Tanker "M A R K A Y"

Dimensions 503 x 68 x 37

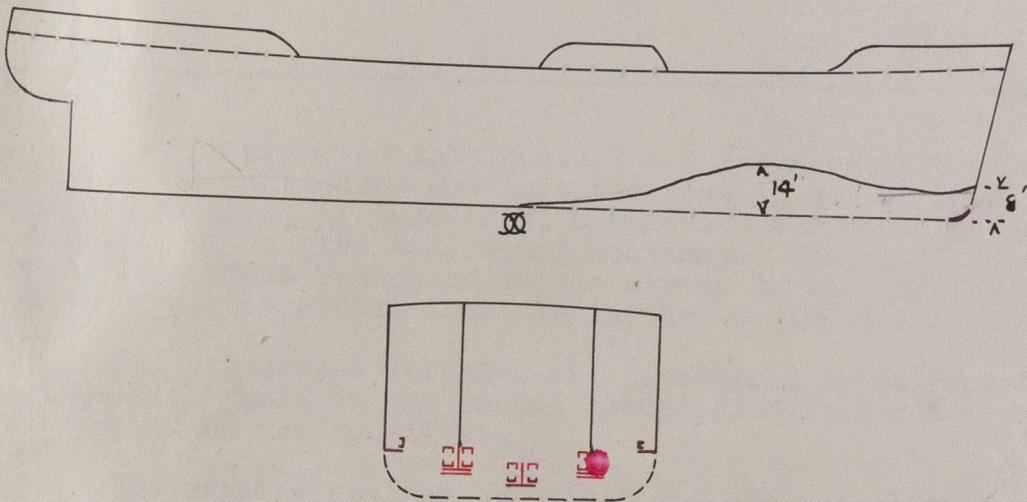
The question of effecting temporary repairs to enable the vessel to proceed to the U.S.A. was discussed in this office by the Owners and Dr. Montgomerie when it was decided that repairs to the bottom as indicated in red in the sketch would be satisfactory for this purpose.

The bottom of the fore peak tank and of the deep tank forward were plated in, as was also the bottom of No.4 tank starboard.

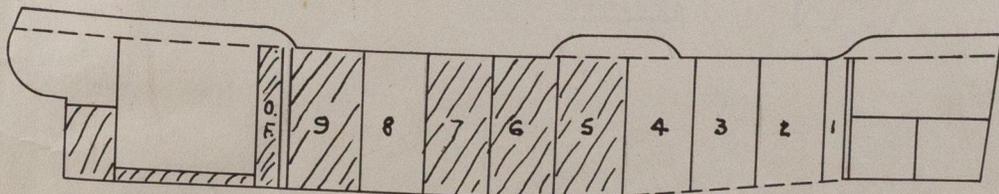
For the voyage the vessel will be loaded as shown below, the estimated draughts being 18' forward and 22' aft.

Mr. Reed, of the Swansea Staff, has made a series of calculations to determine the stress on the vessel in way of the damaged compartments and a visit was paid to Swansea, by the undersigned, accompanied by Mr. Stocks of Cardiff, with a view to examine Mr. Reed's calculations.

These have been based on the ordinary assumed condition of the vessel being poised on either the crest or the hollow of a wave with the following results:- TONS/IN²

<u>Hogging.</u>	<u>Sagging.</u>
<u>Normal vessel, fully loaded.</u>	<u>Bottom</u>	:: - 2.8 ::	+ 8.0
<u>Vessel as repaired, loaded as proposed.</u>	<u>Deck.</u>	:: + 2.6 ::	- 7.5
		:: ::	
Aft end of No.4 tank	<u>Bottom</u>	:: - 4.0 ::	+ 3.0
Fore " " "		:: - 4.1 ::	+ 4.4
Middle of No.3 tank		:: - 4.0 ::	+ 4.8
		:: ::	
		:: ::

It is proposed that Nos.1,2 & 4 tanks be left open at the deck to the atmosphere but that the deck in way of No.3 tank be sealed so that, if necessary, compressed air could be used in this compartment to give additional buoyancy. This will result structurally in a small reduction in the stress in the hogging condition and a corresponding increase in the sagging condition.

The calculated stresses are considered to be reasonable in comparison with those in the normal loaded condition and such as could be accepted by the Committee.
